FINAL
ENVIRONMENTAL STATEMENT
Related to the Proposed
SEABROOK STATION
Units 1 and 2

SEABROOK STATION
UNITS 1 AND 2

PUBLIC SERVICE COMPANY OF NEW HAMPSHIRE

DOCKET NOS. 50-443 and 50-444

Fig. 11.5. Power-producing capacity existing and planned by Public Service Company of New Hampshire.

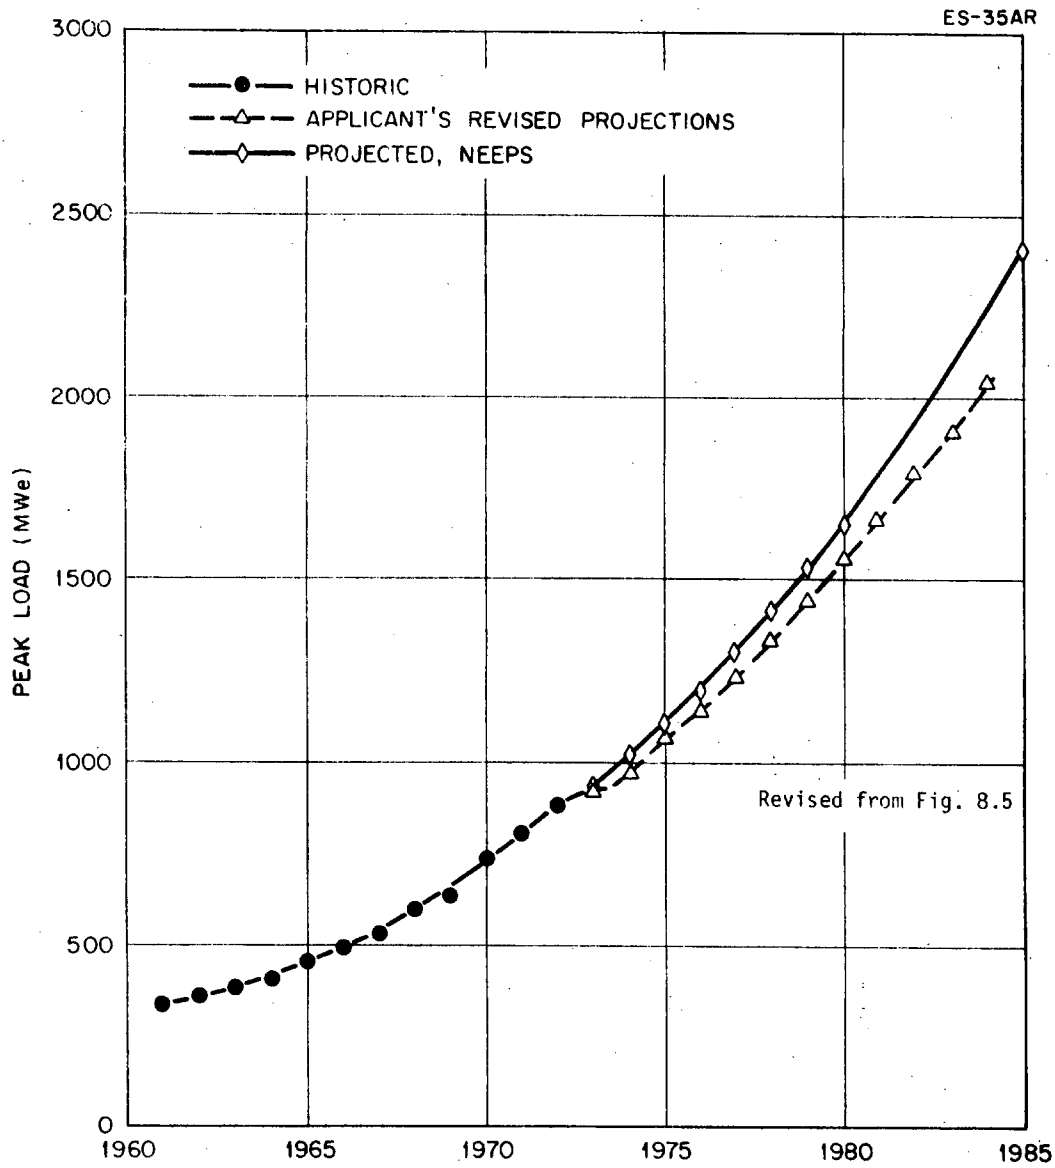
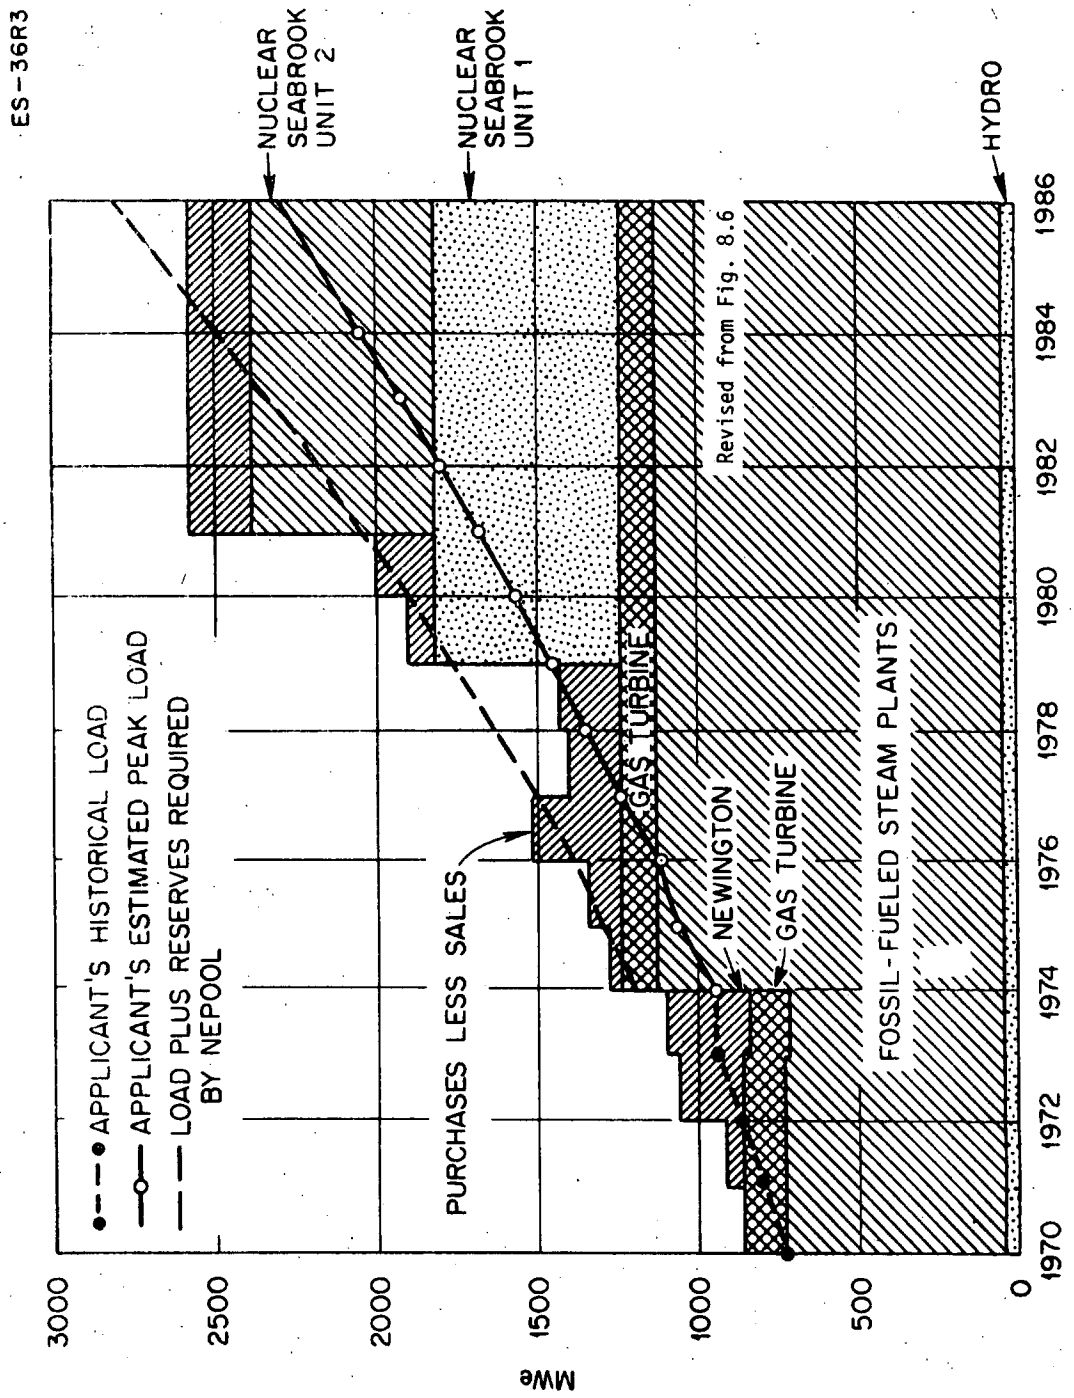
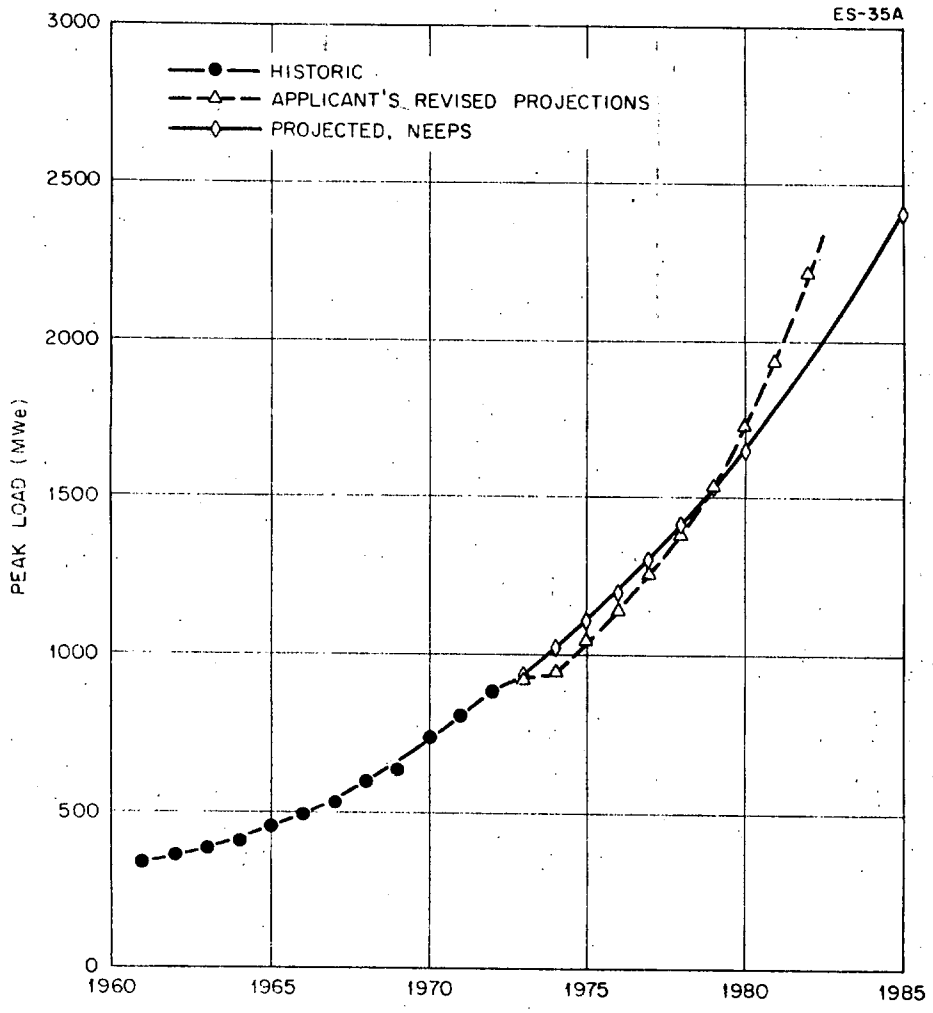
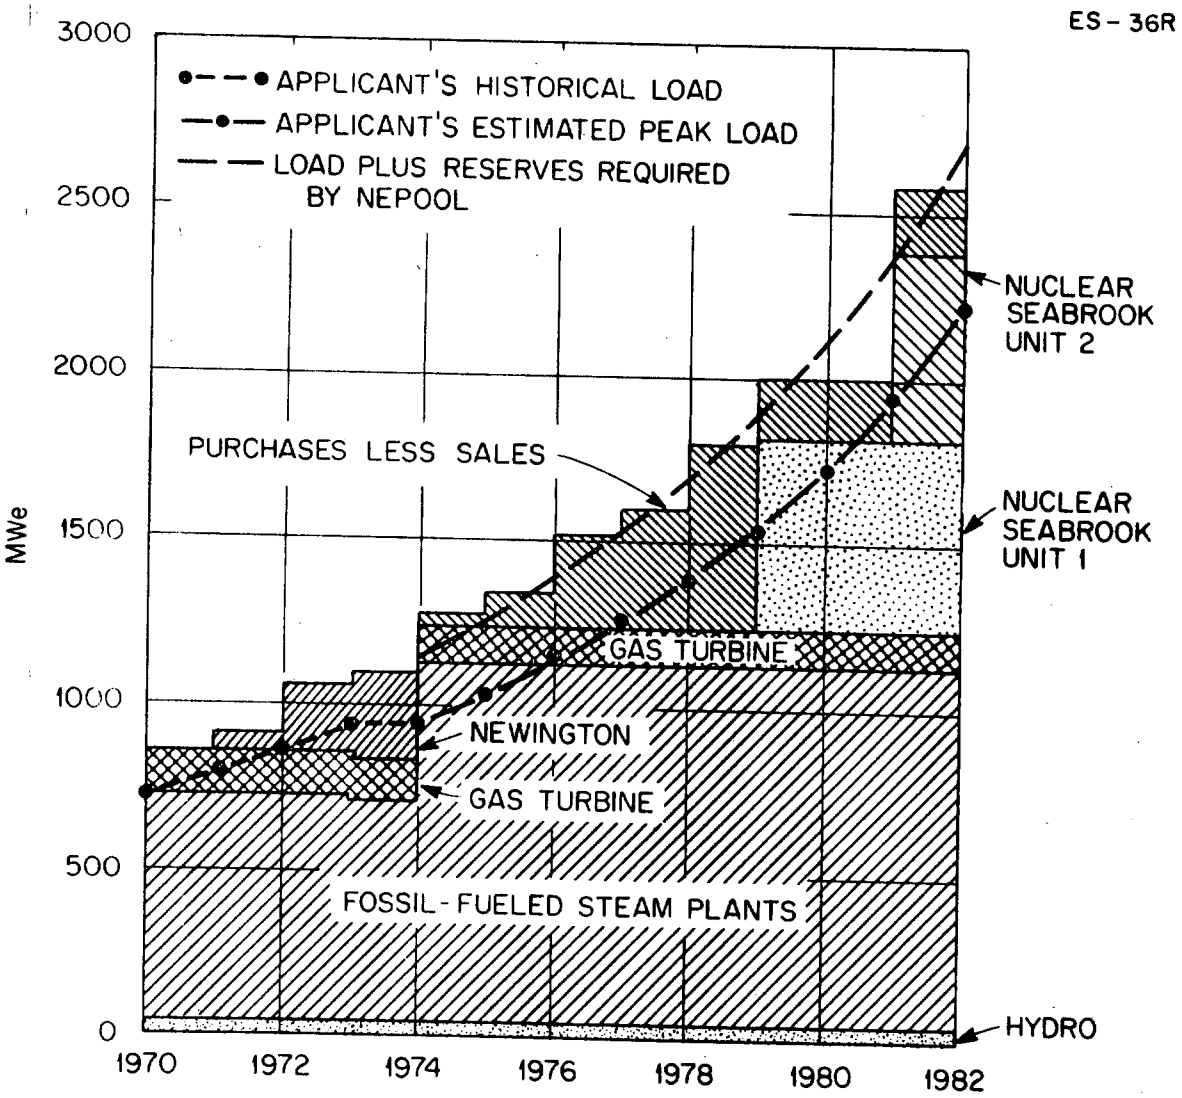
This submittal included a summary of the applicant's peak load and energy output as forecast by the applicant in August 1974. These projections are included on Figures 11.4, and 11.5, which are revisions of Figures 8.5 and 8.6, respectively. The applicant's revised predictions indicate a much lower projected peak demand than that forecast earlier. The excess of purchases over sales has also been significantly reduced for the period 1977-1979. The applicant's new projected reserve margins (including Seabrook Units 1 and 2) for 1975 through 1982 are given below (from Table II of applicant's submission) with the earlier projections in parentheses:

The revised projections given in Figure 11.5 indicate some doubt about the need for Seabrook Unit 2 in 1981 based on projections alone. The projections tend to show that the initial power from Unit 2 might not be needed by the applicant until about 1984, (2 - 3 years after the original schedule date).
